WATTS BAR NUCLEAR PLANT (WBN) - PROPOSED LICENSE AMENDMENT -
CONTAINMENT SYSTEMS

PROPOSED LICENSE AMENDMENT
CONTAINMENT SYSTEMS

FIGURE 1
ICE CONDENSER BAYS NUMBERING SEQUENCE.

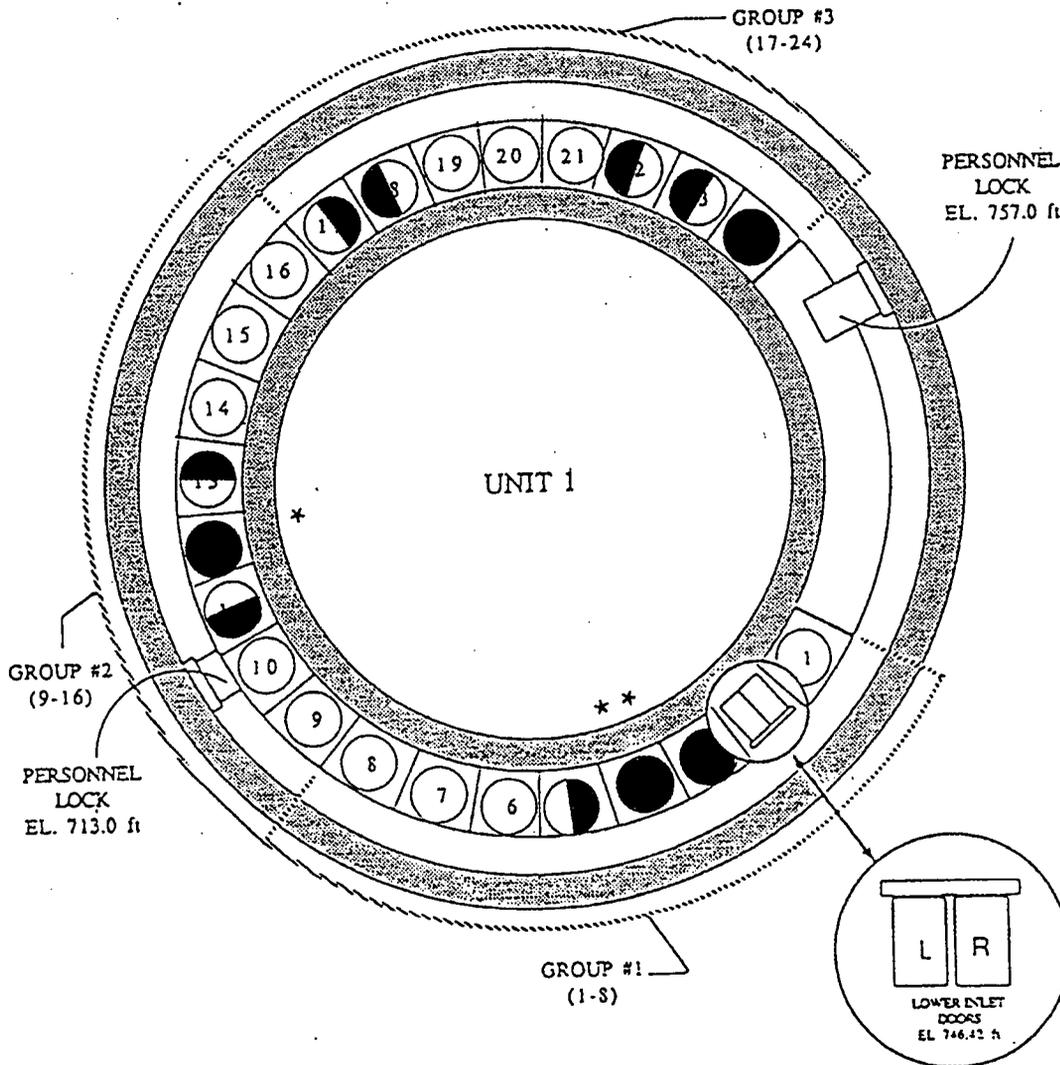
Since Watts Bar was issued a license on November 9, 1995, this surveillance has been performed four times. During the four performances of this surveillance, only the May 13, 1996, performance identified doors which initially failed a portion of the acceptance criteria. Specifically, 15 doors failed the 40 degrees opening torque (1 door by 23 percent or 45.75 inch lbs, 1 door by 13 percent or 25.68 inch lbs, and 13 doors by 2.8 percent or 9.5 inch lbs). In addition, three of the 15 did not meet the calculation for frictional torque value of this SR by 0.3 percent or 0.125 inch lbs. From these values, it can be seen that only two of the doors were moderately over the criteria with the remaining 13 only slightly exceeding the criteria. (See Figure 1 for a location map reflecting the results distribution.)

Conduct of the May 13, 1996, surveillance yielded initial "as-found" test results which indicate that 15 of the 48 lower inlet doors did not meet the 40 degrees open position opening torque (13 by an average of 2.8 percent, one by 13 percent and one by 23 percent). This has been evaluated by TVA and Westinghouse as to the potential effect on current design basis analysis. The review also addressed three doors which exceeded the overall friction criteria by 0.3 percent. The evaluation consisted of a review of the Subcompartment analysis, Long-Term LOCA Containment analysis, Long-Term MSLB Containment analysis, Maximum Reverse Differential Pressure analysis, and Deck Bypass. The result of these analyses, indicates that the "as-found" deviations in ice condenser inlet door opening performance are still bounded by the current licensing design basis containment related accident analysis. In addition, since the "as-left" conditions were within the TS requirements and a subsequent performance on May 17, 1996, did not

To address the May 13, 1996, test deficiencies, the subject doors were exercised in place and the tests performed again with successful results. The surveillance was performed again on May 17, 1996, just prior to unit startup with all doors passing the acceptance criteria.
